SHEET
SECTION 3

PROJECT
GND FL REAR EXT'N

CLIENT
N. RAMUS & L.EVANS,
30 ARMOUR ROAD,
TILEHURST, READING,
BERKS. RG31 6HN

DRAWING NUMBER
RAMUSEVANS-TD-24-319-P7

Section 3

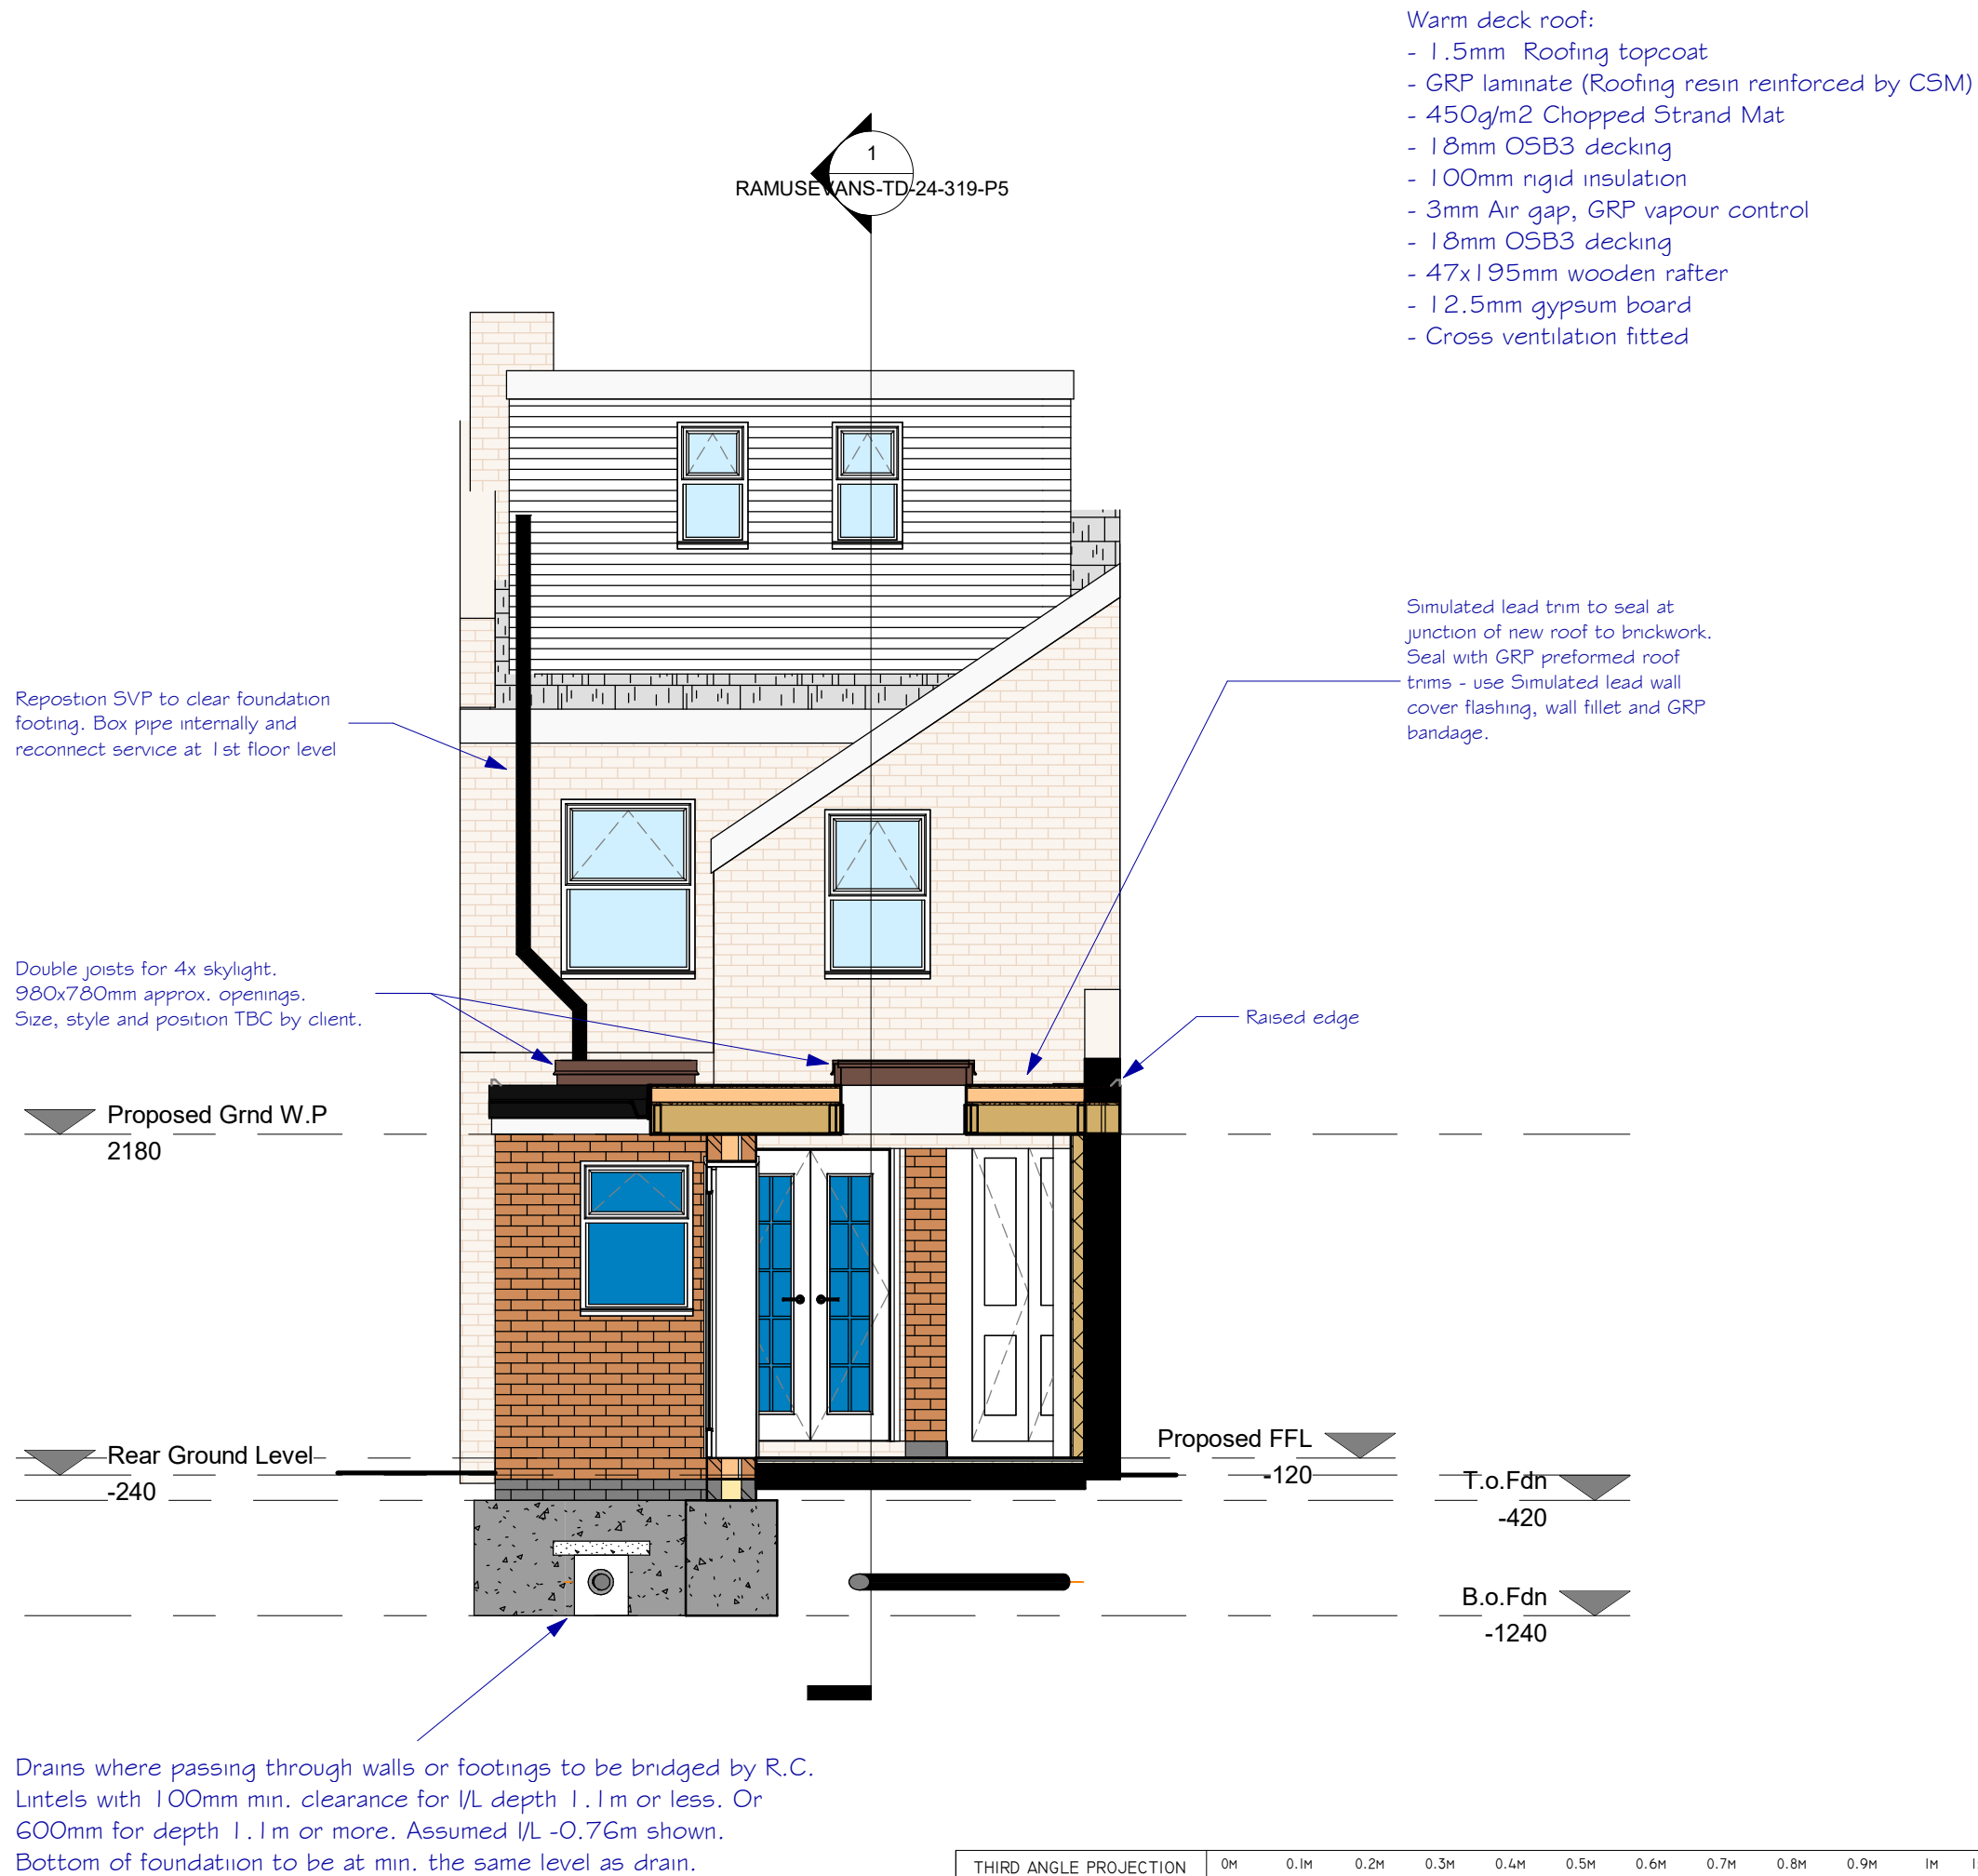
3. 31.07.24 -
*reduce roof height of proposed ext'n.
*remove parapet walls each side of roof and replace with raised edge instead.
2. 15.07.24 -
*resize to 8m total length
*step-in ext'n footprint to negate tunnel effect on neighbour
